UNITED STATES PATENT AND TRADEMARK OFFICE

APPLICATION NO.	FILING DATE	FIRST NAMED INVENTOR	ATTORNEY DOCKET NO.	CONFIRMATION NO.
10/765,391	01/28/2004	Anthony Di Bitonto	B0224.0079	2535
32172	7590	12/02/2005	EXAMINER	
DICKSTEIN SHAPIRO MORIN & OSHINSKY LLP 1177 AVENUE OF THE AMERICAS (6TH AVENUE) 41 ST FL. NEW YORK, NY 10036-2714			NGUYEN, PHONG H	
			ART UNIT	PAPER NUMBER
			3724

Office Action Summary

DETAILED ACTION

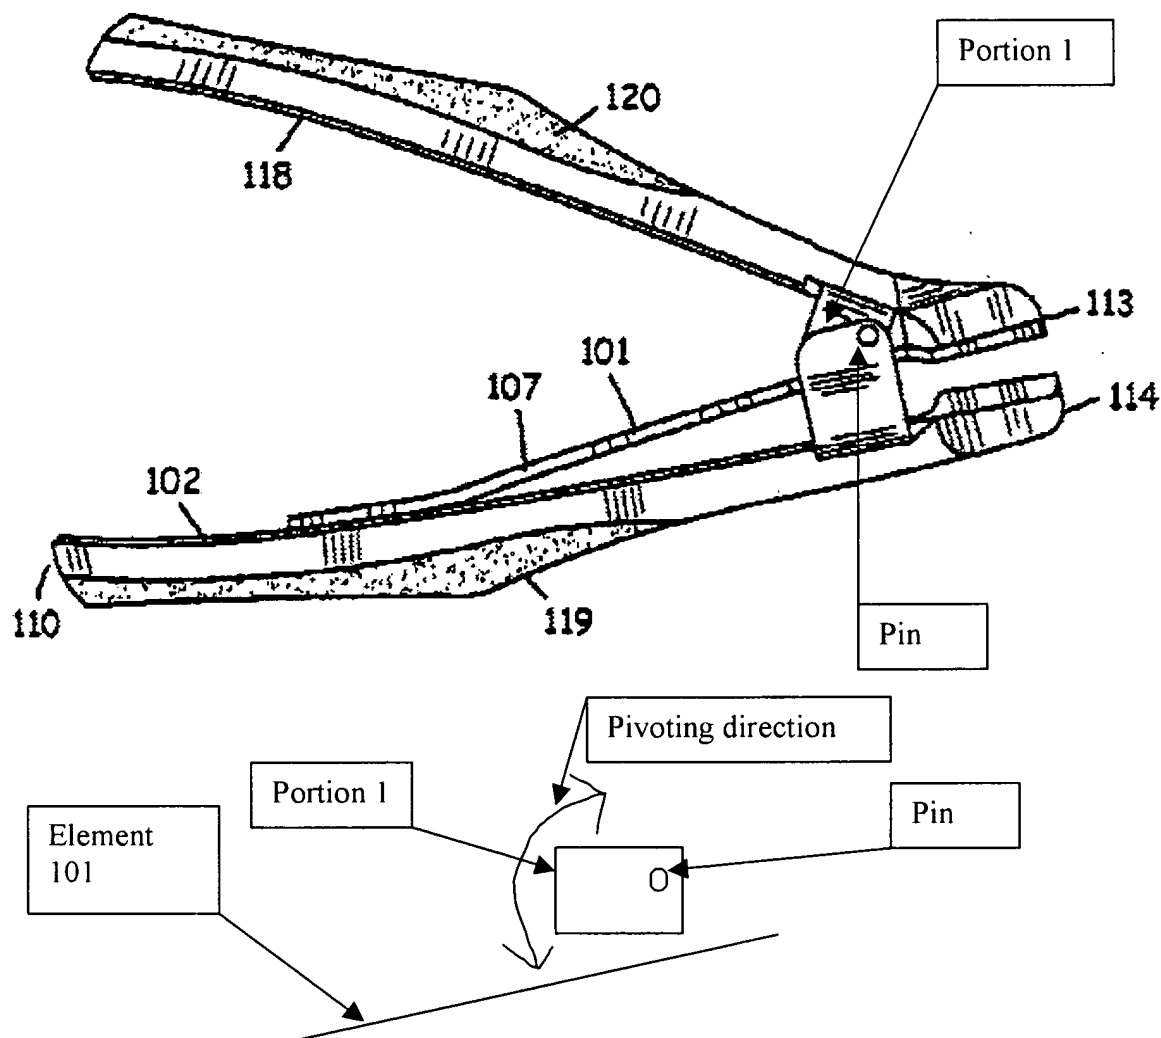
It is unclear whether the Applicant claims the triangle shaped bumpers being provided on the nail clipper in Fig. 4 or Fig. 5. There is no indication in the Specification that the triangle shaped bumpers can be used in the nail clipper in Fig. 4. The allowability cannot be commented on at this time in view of the issues under 37 CFR 1.71 and 35 USC 112.

Regarding Applicant's argument with respect to the drawings, merely adding a label 117 to Fig. 5 does not overcome the drawing objection with respect to claim 1. The

corrected Fig. 5 does not show the post extending above the top surface of the top member. It appears that the nail clipper in Fig. 5 can function without the post. For example, portion 1 pivots about a pin to press down the top member. See below Figure and sketch. Therefore, more clarification of Fig. 5 is needed.
